SENSENICH PROPELLER CO., INC.

FAQ FOR SERVICE BULLETIN SB2016-06B1

Service Bulletin [SB2016-06B1](#) contains all the definitive information for model and serial number applicability. This FAQ provides supplemental information to illustrate the following: model and serial number identification, previous service bulletins, hub model progression and pitch system variations, crack location and inspection recommendations, blade retention redundancy, and options available for compliance with the service bulletin.

Figure 1. Hub Model 2A0 Series Revision "D" and earlier

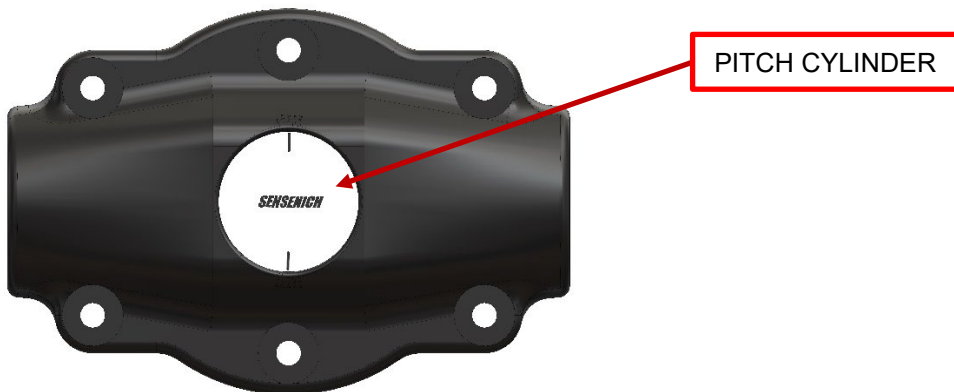
Affected hubs:

Models 2A0J5 and 2A0R5, revision "0", "A", "B", "C", and "D".

See Figure 1.

The first several years of hub production did not include a stamped model number on the part.

Identification is denoted by the presence of the white pitch cylinder.

The serial number last digit indicates the revision level: If the last digit is a number, then it is revision "0", otherwise there is a letter such as "A", "B", etc...

Revision "D" was the last hub revision which incorporated the pitch cylinder feature.

Figure 2. Hub Model 2A0 series Revision "E" and later

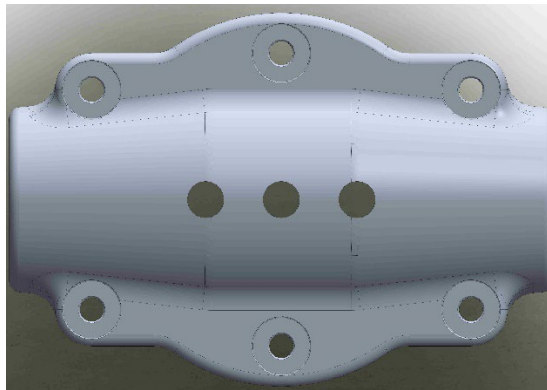
- Revision "E" or later 2A0 series hubs with three ½" diameter holes in the hub cover half are not affected. See Figure 2.

Figure 3. Hub Models 2A1R5 and 3A0B7, respectively

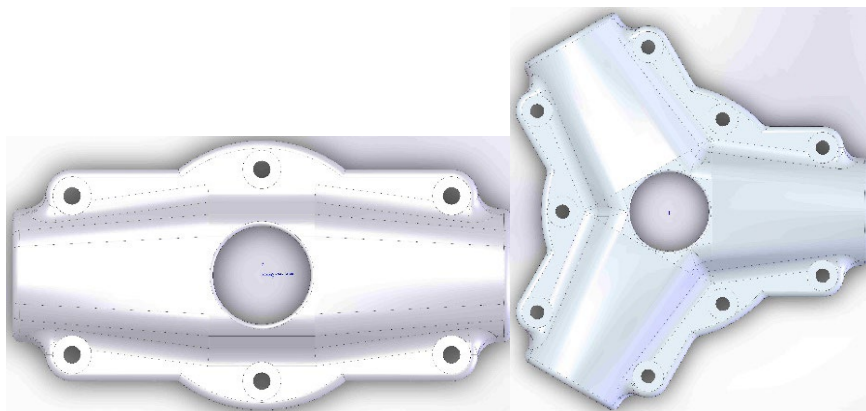
- Model 2A1R5 and 3A0B7 hubs with long blade shanks are not affected. While they do incorporate the white pitch cylinder, the blade retention geometry is significantly longer and different from the compact 2A0 series so that this service bulletin does not apply. See Figure 3.

Figure 5. Unattended cracks may progress to edges of hub cover half.

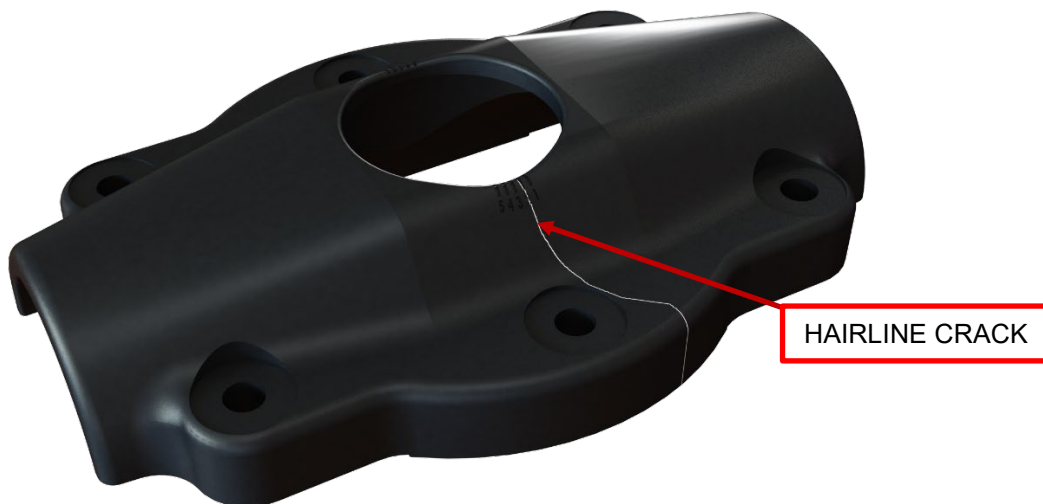
- The hub cracks typically start at or near the pitch marks on the sides of the central hole, and grow outwards towards the hub sides. They are hairline cracks which are very difficult to see with the naked eye. We recommend using very good lighting, a 10x magnifying glass and inspecting the inside of the pitch cylinder hole in the hub cover next to the pitch marks.
- See Figures 4 through 6 below. Figure 4 shows the best location for inspection, on the inside of the hub cover pitch cylinder hole.
- The hub cover must be removed from the propeller assembly for thorough inspection inside the pitch cylinder hole. *Inspection of the hub exterior is not adequate.*
- Hub color/plating does not appear to be a factor, but the black anodize makes inspection more difficult.
- This inspection must be performed every 50 flight hours or annually, whichever comes first.

Figure 4. Cracks start near pitch marks and grow outwards. Inspection inside the hub cover is required.

Inspect affected hub cover every 50 flight hours or annually, whichever comes first. This requires removal of the spinner dome and spinner front plate (if used) so that the inside of the hub cover can be inspected.

Figure 6. Nord-Lock Lock Washer

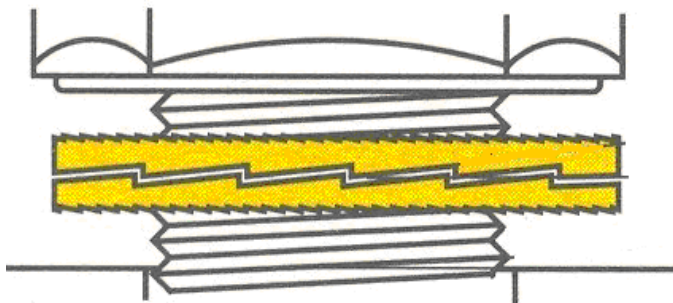
Nord-lock washers work in pairs with the ramped sides facing each other. See Figure 6.

During loosening, the Nord-lock washers may click loudly; this is normal. Inspect Nord-lock washers on the inside cam surfaces and outside serrations. Replace washers with excessive wear.

Lubricate acceptable washers with a light coating of engine oil or equivalent.

Figure 6. Clamp Bushing Engagement into Hub Cover

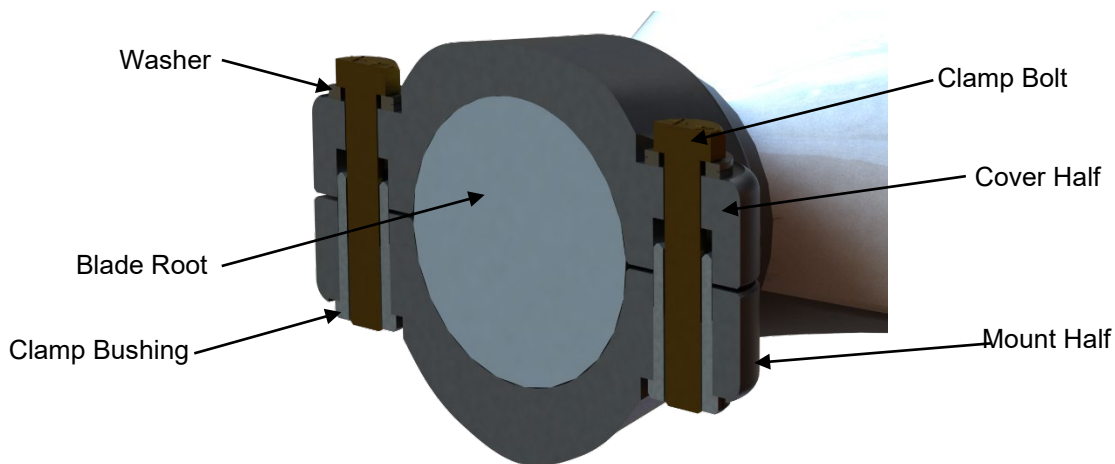
One design element which increases the retention safety for the 2A0 hub series is the incorporation of threaded clamp bushings. These bushings are press fit in the hub mount half and engage the hub cover half when the propeller blades are pitched and clamp bolts fully torqued. This ensures that the propeller clamp bolts do not carry any shear loads even if the hub cover cracks into two pieces.

NOTE: The clamp bushings provide blade retention backup *and do not change the 50 hour inspection interval for this service bulletin.*
